**ADDENDUM TO THE CONTRACT  
for the  
Auke Bay Elementary  
School Renovation Re-Bid  
Contract No. E12-216**

**ADDENDUM NO.: THREE**

**DATE ADDENDUM ISSUED: March 2, 2012**

**A101**

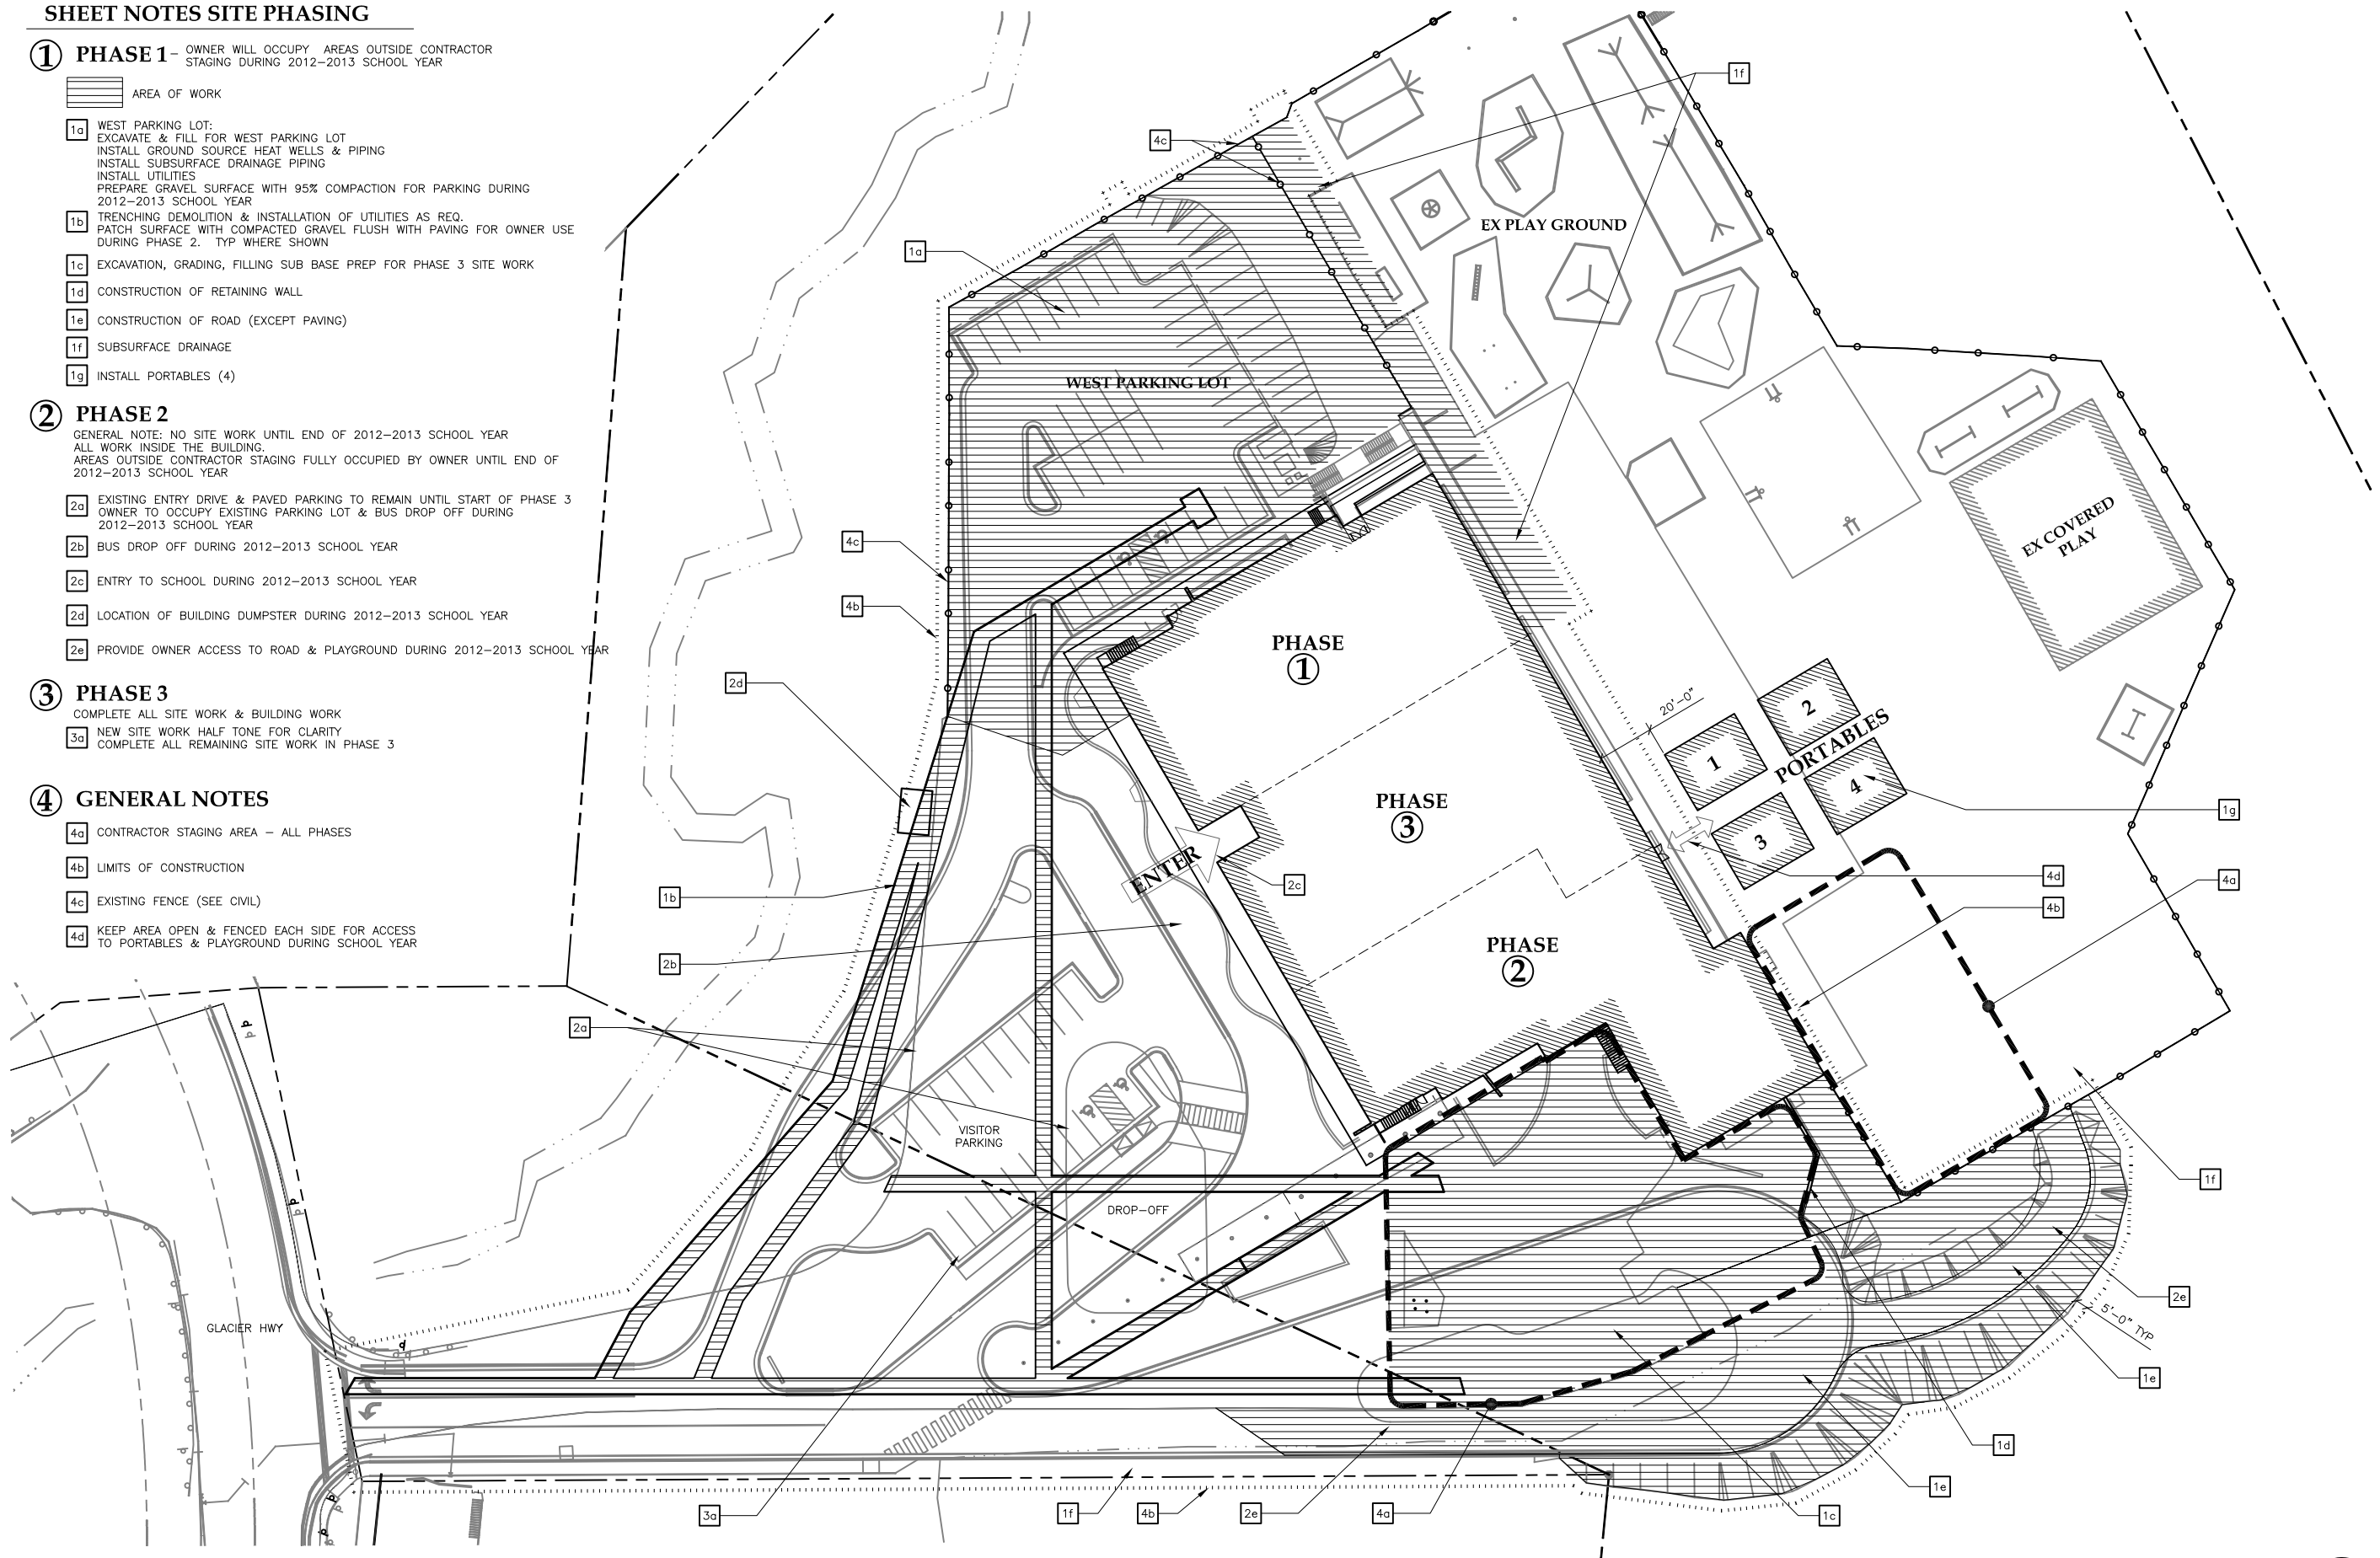
15. Sheet A101: Replace Sheet A101 added in addendum 2 of project E12-216 with the attached Sheet A101 labeled addendum 3. This has been change to indicate 4 portables.

▲ MD702

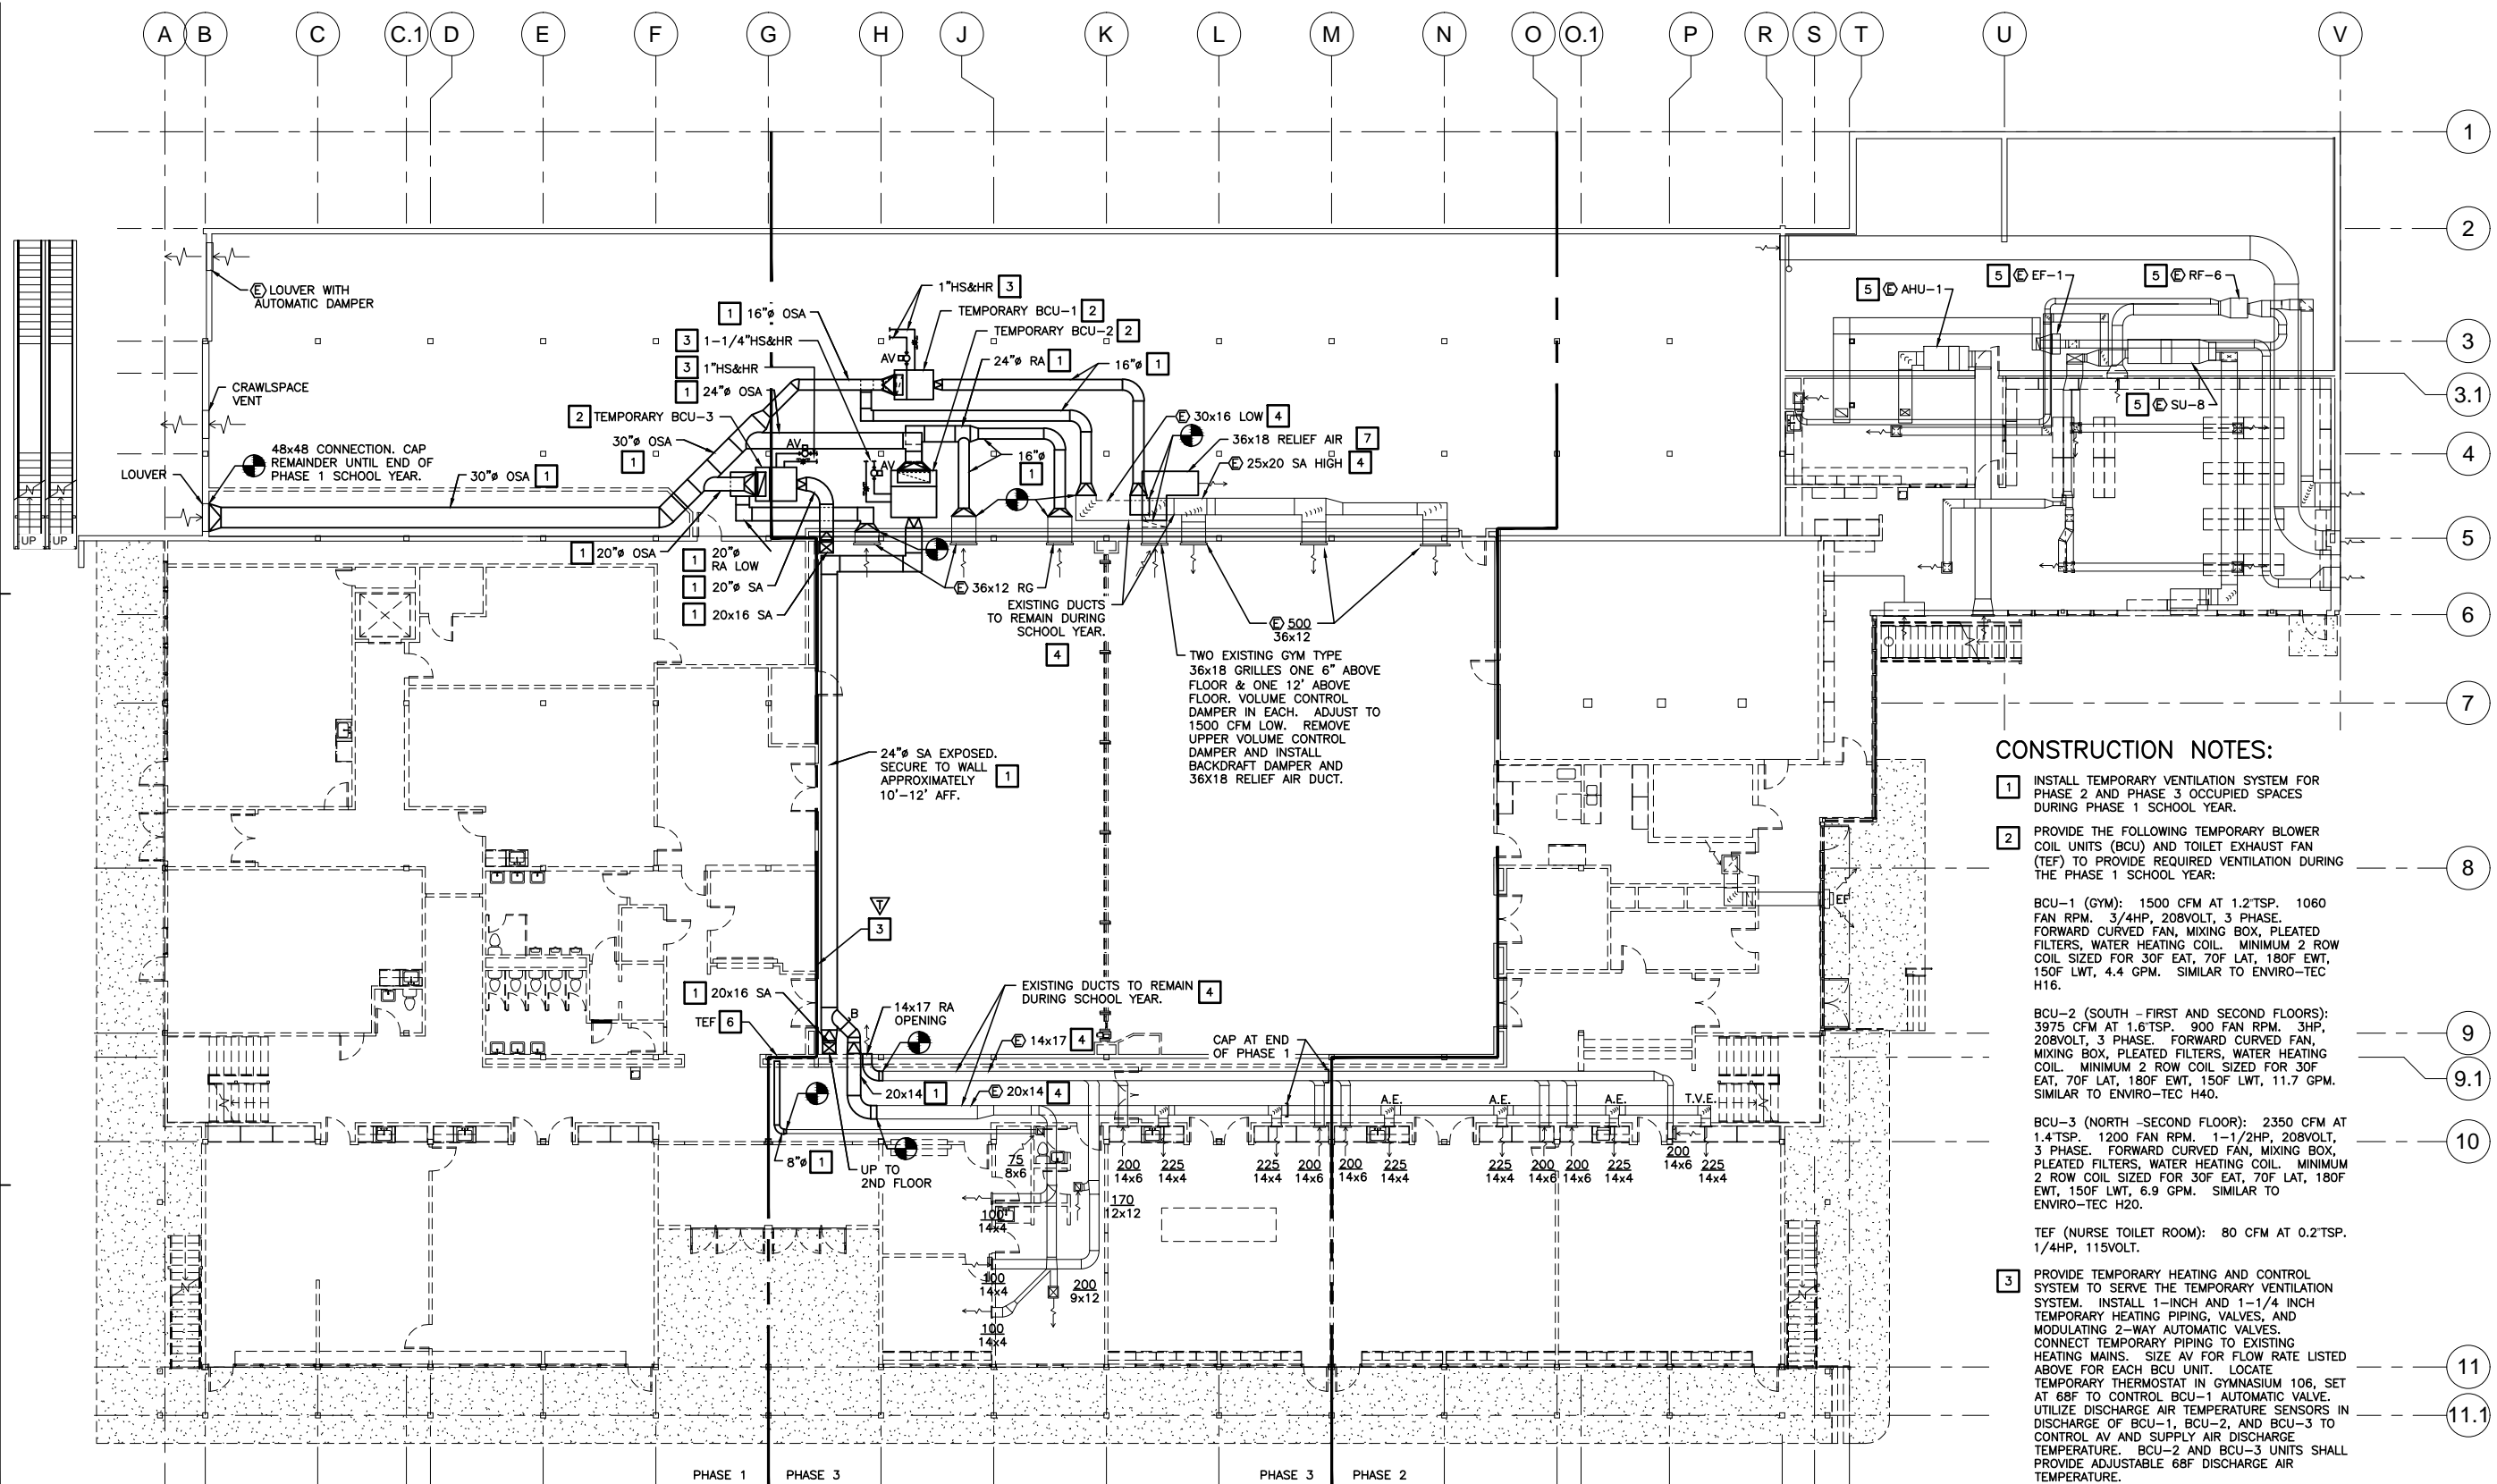
32. Sheet MD702: Add Drawing MD702 labeled addendum 3 (attached). MD702 details the temporary mechanical ventilation system required to provide ventilation to the Occupied Phase 2 and Phase 3 portions of the building during the Phase 1 School Year Construction period. Provide necessary Mechanical, Controls, and Electrical Work as required.

- 1. INSTALL TEMPORARY VENTILATION SYSTEM FOR PHASE 2 AND PHASE 3 OCCUPIED SPACES DURING PHASE 1 SCHOOL YEAR.
- 2. PROVIDE THE FOLLOWING TEMPORARY BLOWER COIL UNITS (BCU) AND TOILET EXHAUST FAN (TEF) TO PROVIDE REQUIRED VENTILATION DURING THE PHASE 1 SCHOOL YEAR:

- 4. ADJUST AND BALANCE TEMPORARY VENTILATION SYSTEM TO PROVIDE SUPPLY AIR VOLUMES SHOWN ON MD702 AND MD703 PRIOR TO THE START OF THE PHASE 1 SCHOOL YEAR. ADJUST MIXING DAMPERS AT BCU UNITS AS NECESSARY TO PROVIDE THE FOLLOWING OUTDOOR AIR VOLUMES DURING OCCUPIED PERIODS: BCU-1: 750 CFM, BCU-2: 2000 CFM, BCU-3: 1250 CFM.
